To: Plan Holders for Improvements to the
Farmington Regional Airport
Farmington, Missouri
Project No. 22-061C-1

**ADDENDUM NO. 1
TO
CONTRACT DOCUMENTS, SPECIFICATIONS AND PLANS
FOR IMPROVEMENTS TO THE
FARMINGTON REGIONAL AIRPORT
FARMINGTON, MO
PROJECT NO. 22-061C-1**

RUNWAY 2/20 LIGHTING REHABILITATION

SHEET NAME G005
SHEET NO. 6 of 51

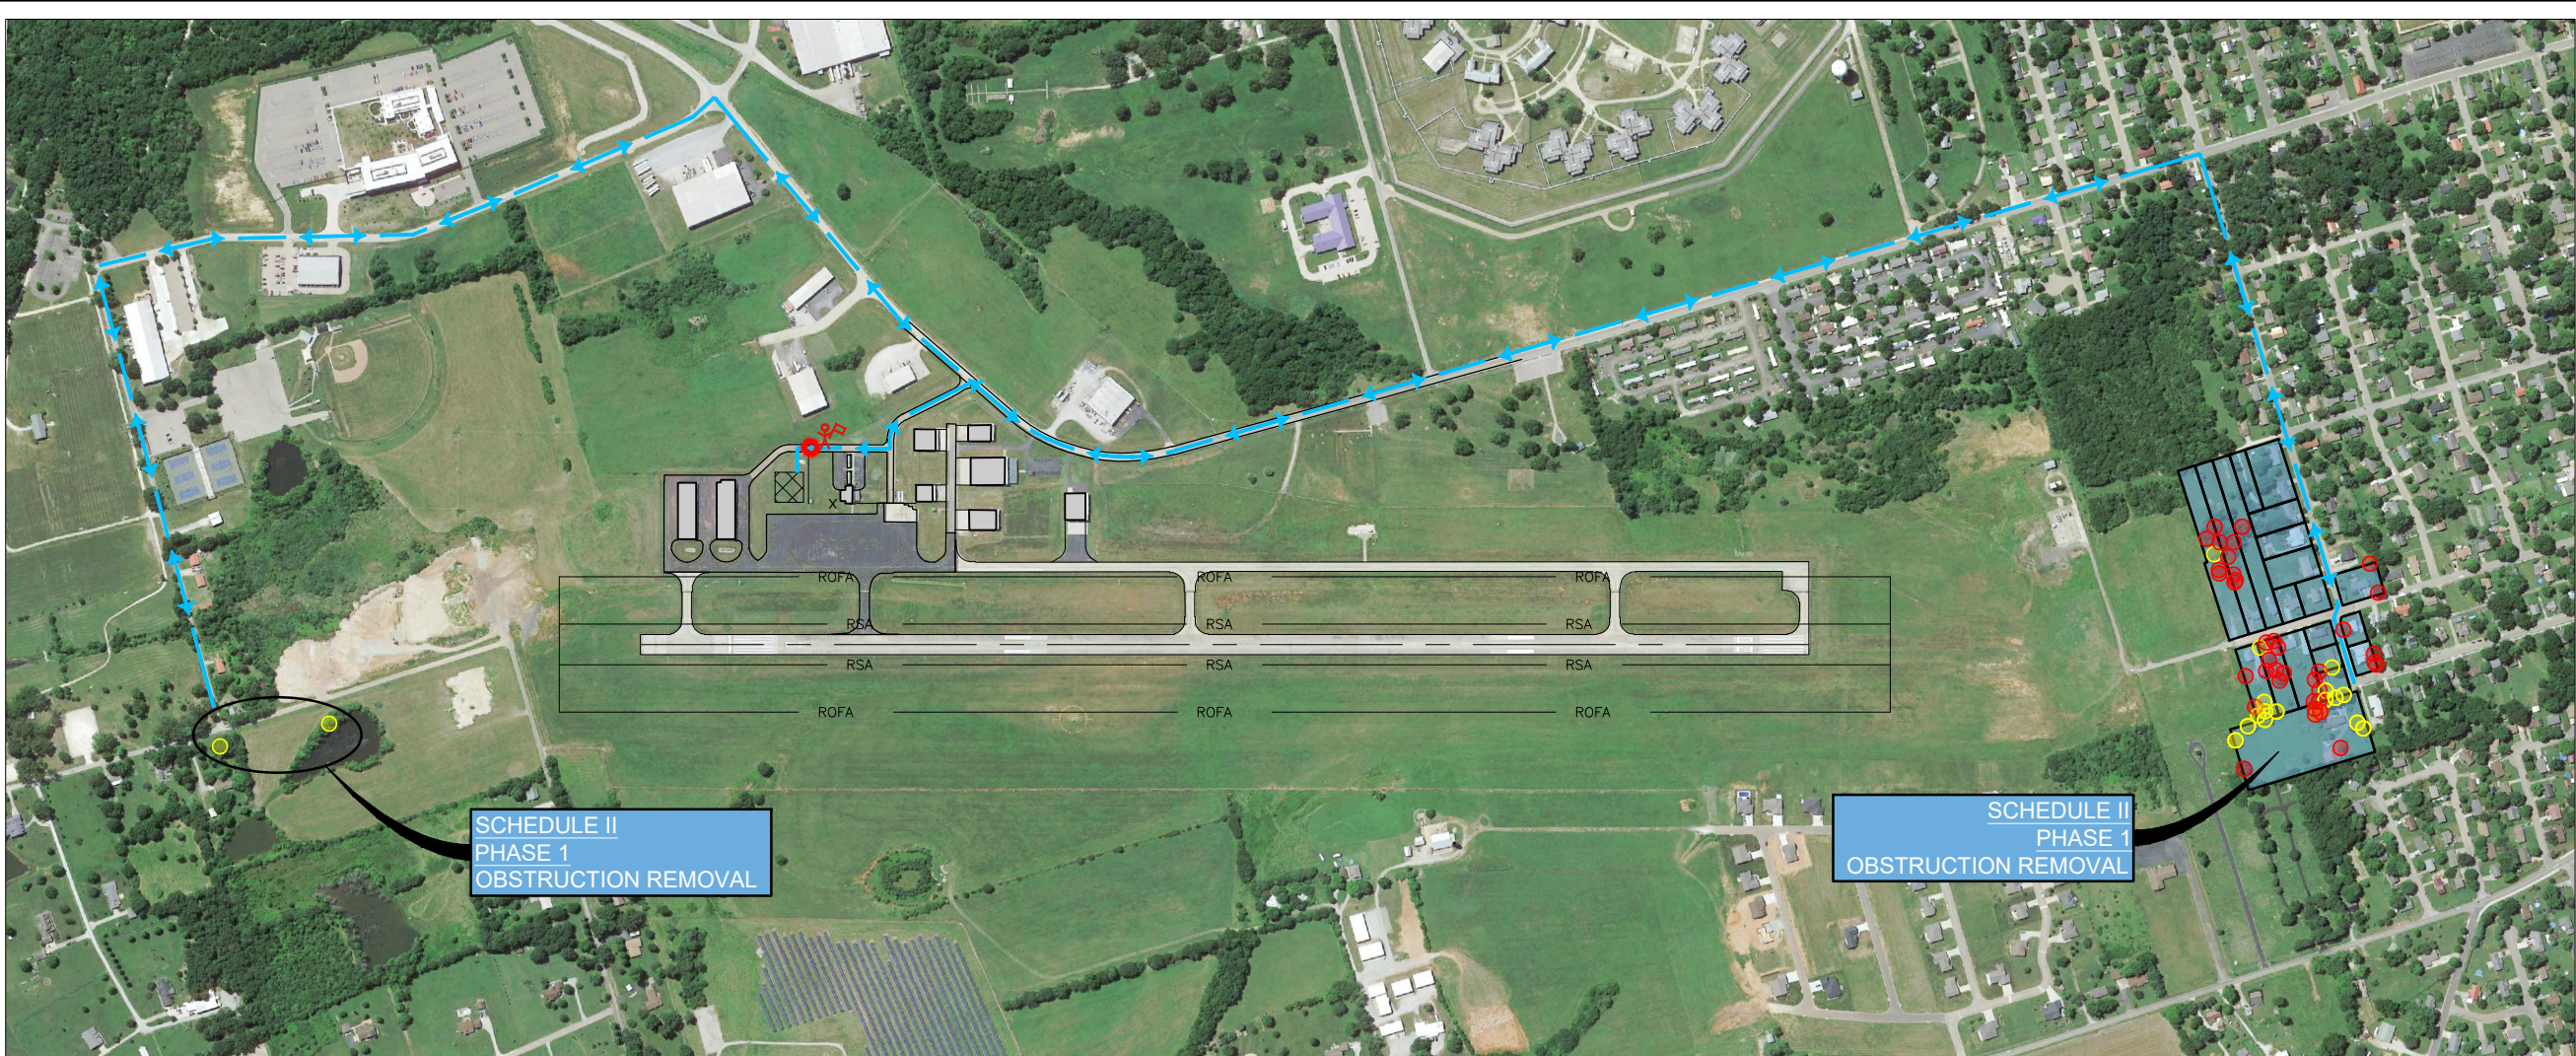
G005 - (6 of 51) – SUMMARY OF APPROXIMATE QUANTITIES

Justification: The approximate quantities table has been updated to reflect the changes.

SHEET NAME G054

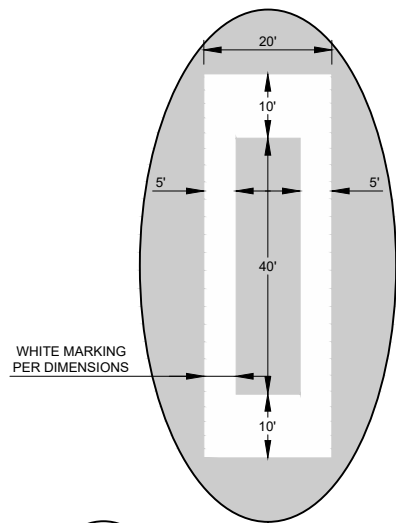
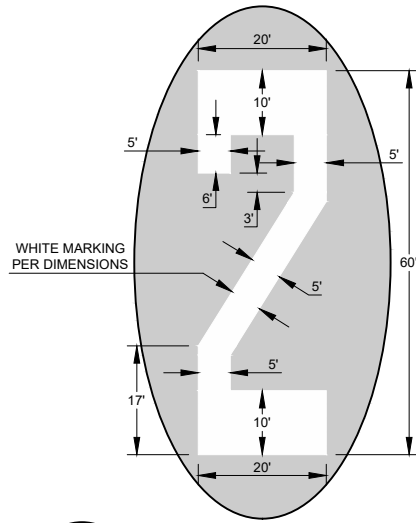
G054 – (12 of 51) – Updated to show the base bid and alternate no. 3.

Justification: To better clarify the difference in the base bid vs Alternate No. 3 obstructions. To also include the updated obstructions.

C250

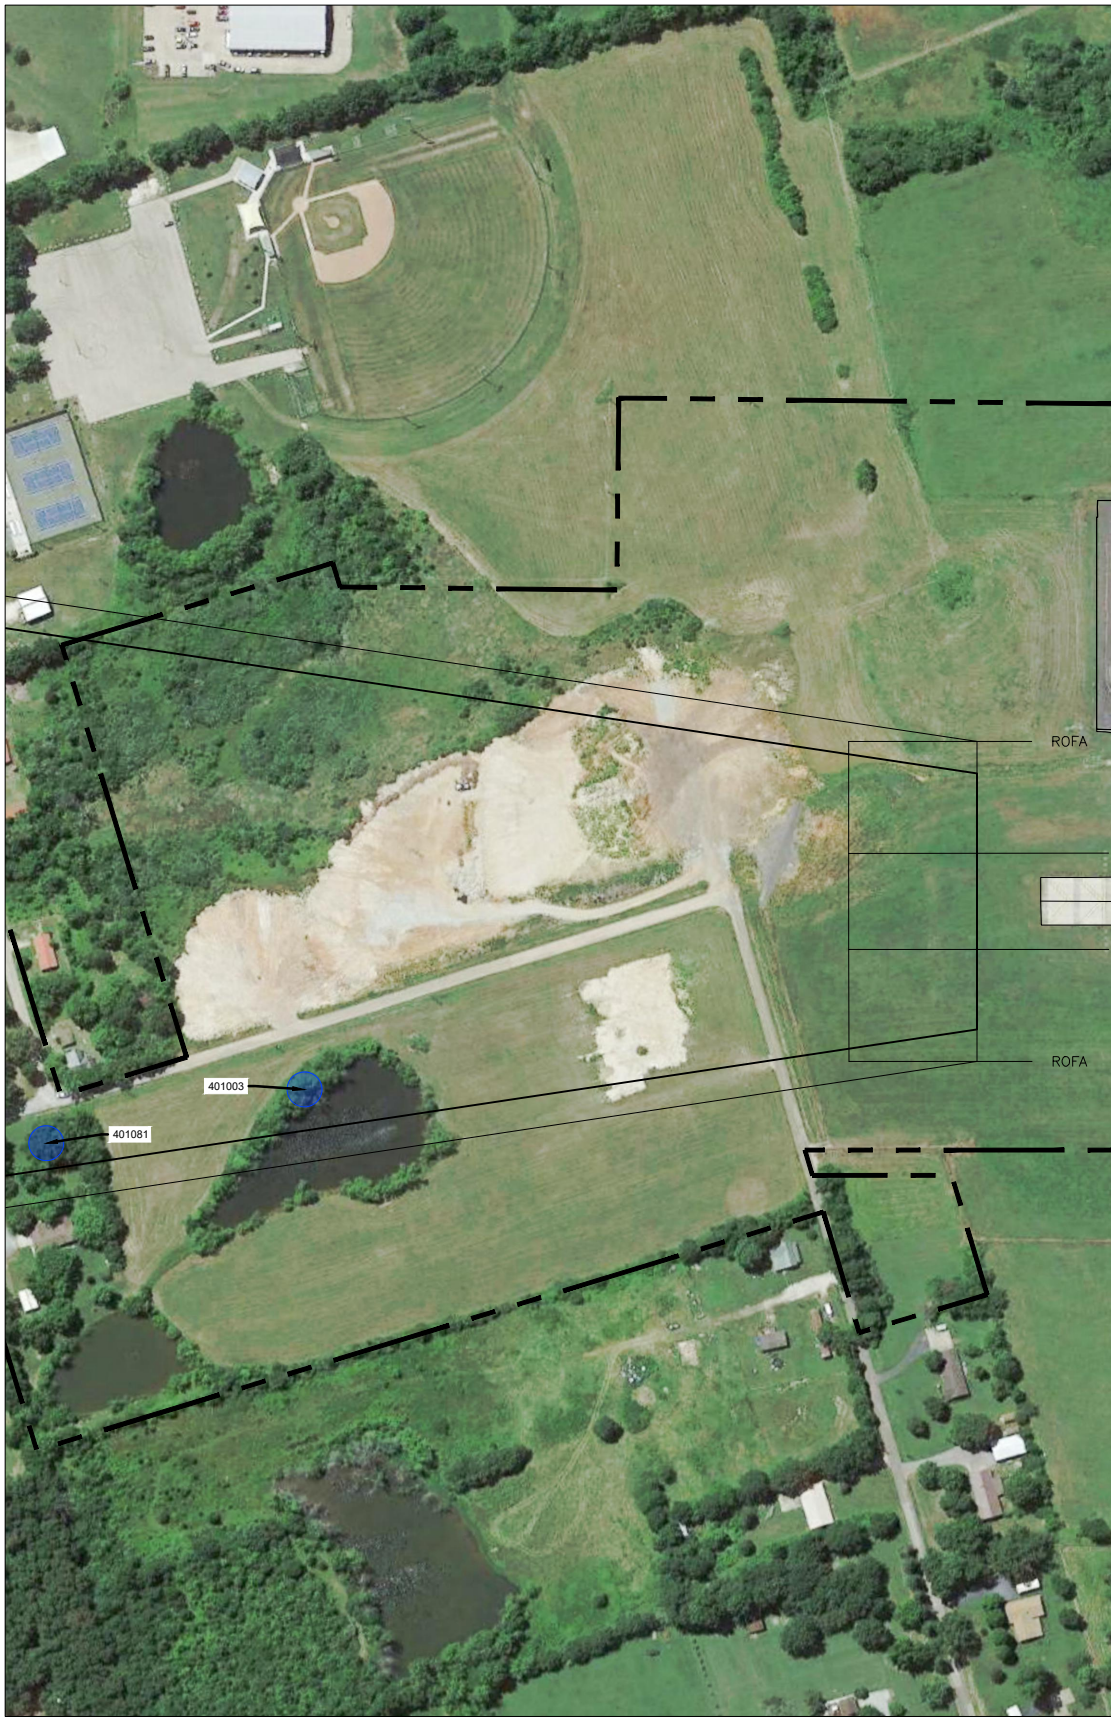
C250 - (28 of 51) – Remove General Marking note #3 & #6 from sheet C250

Justification: To clarify there are no striated runway markings nor temporary paint.
